**Committee of Experts on the Transport of Dangerous Goods  
and on the Globally Harmonized System of Classification  
and Labelling of Chemicals****Sub-Committee of Experts on the Transport  
of Dangerous Goods****Fifty-seventh session**

**Classification and labelling criteria and related hazard  
communication: work of the Sub-Committee of Experts on  
the Transport of Dangerous Goods (TDG) on matters of  
interest to the GHS Sub-Committee****Manual of Tests and Criteria, review of Test Series H:  
determination of self-accelerating decomposition  
temperature****Transmitted by the Chairman of the Working Group on Explosives\*****Introduction**

1. This document contains the outcome of the work of the International Group of Experts on the Unstable and Energetic Substances (IGUS), working group Energetic and Oxidizing Substances (EOS), ad-hoc working group on revision of test series H. The information in this document was presented earlier in informal documents INF.31 (fifty-sixth session) and INF.15 (thirty-eighth session).

“Figure 28.4.2.2: Example of determination of SADT or SAPT

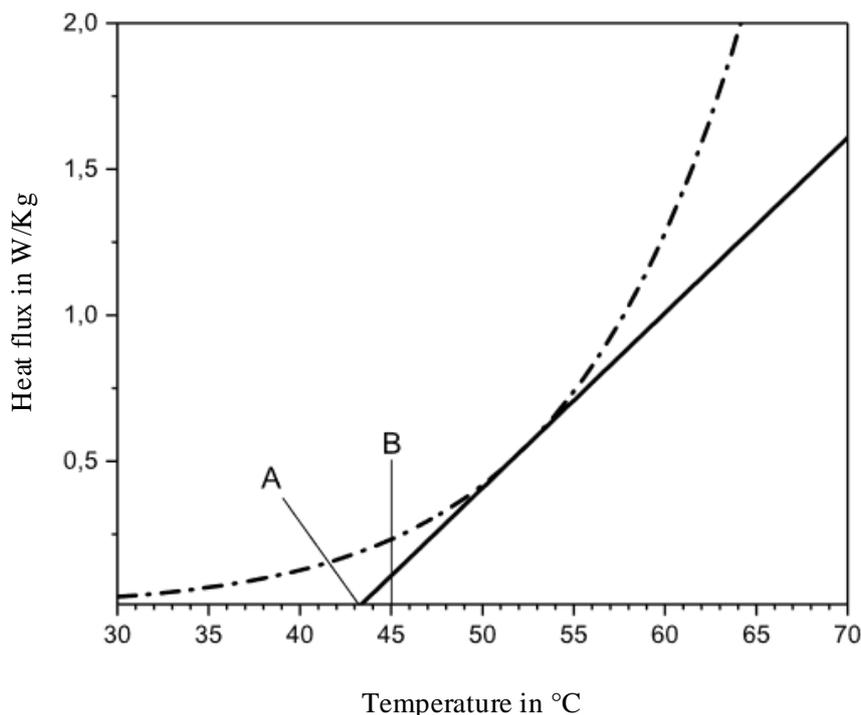
Figure 28.4.2.2 Replace with the following:

— · — ·	Heat generation curve	—	Heat loss curve $L = 0.06 \text{ W (Kg K)}$
(A)	Critical ambient temperature (intercept of heat loss with the abscissa)	(B)	SADT or SAPT (Critical ambient temperature rounded up to next higher multiple of 5°C)

**“Figure 28.4.3.1: Measuring period as a function of maximum heat generation measured**

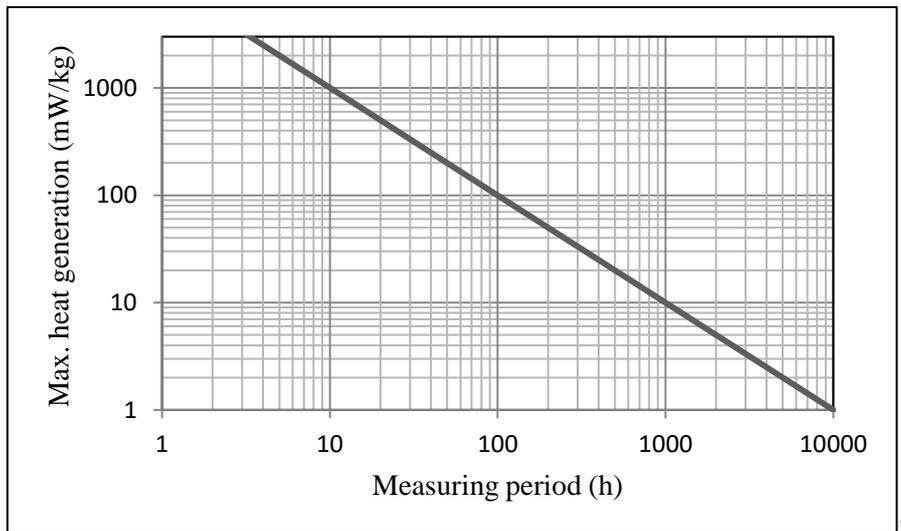
- (c) Start monitoring the rate of heat production. The duration of each test depends on the test temperature and on the rate of heat production. The measuring time as given in Figure 28.4.3.1 can be used as guidance unless it leads to unrealistic measuring times (e.g. greater than 1000 hours). These measuring times are given to achieve a certain degree of conversion of the substance in order to take auto-catalytic effects into account;<sup>3</sup>

Figure 28.4.3.1 Insert the following new figure:

**“Figure 28.4.3.2: Example of determination of SADT or SAPT**

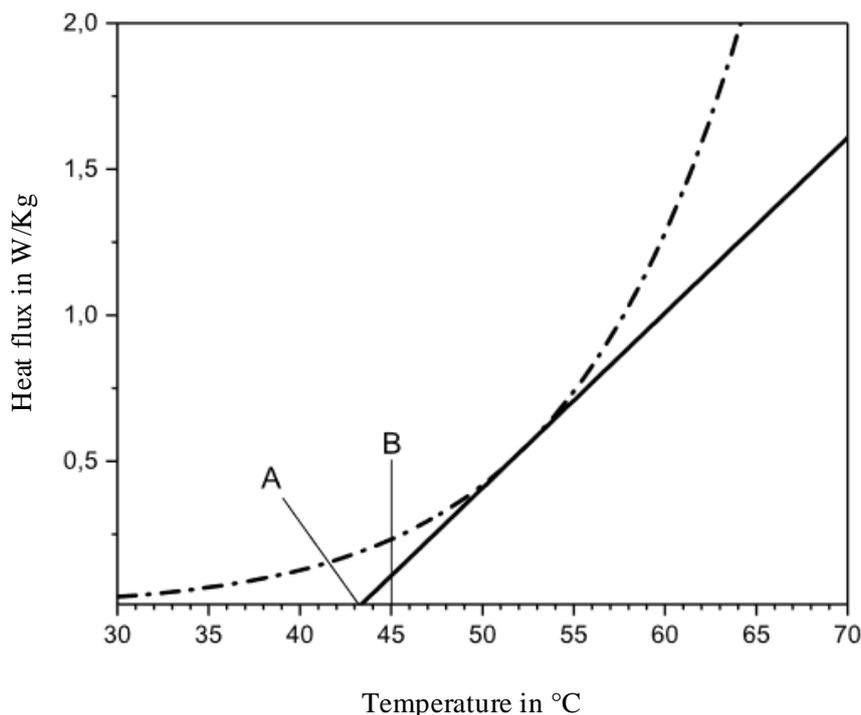
Insert the following new figure 28.4.3.2:

— · — ·	Heat generation curve	—	Heat loss curve $L = 0.06 W (Kg K)$
(A)	Critical ambient temperature (intercept of heat loss with the abscissa)	(B)	SADT or SAPT (Critical ambient temperature rounded up to next higher multiple of 5°C)
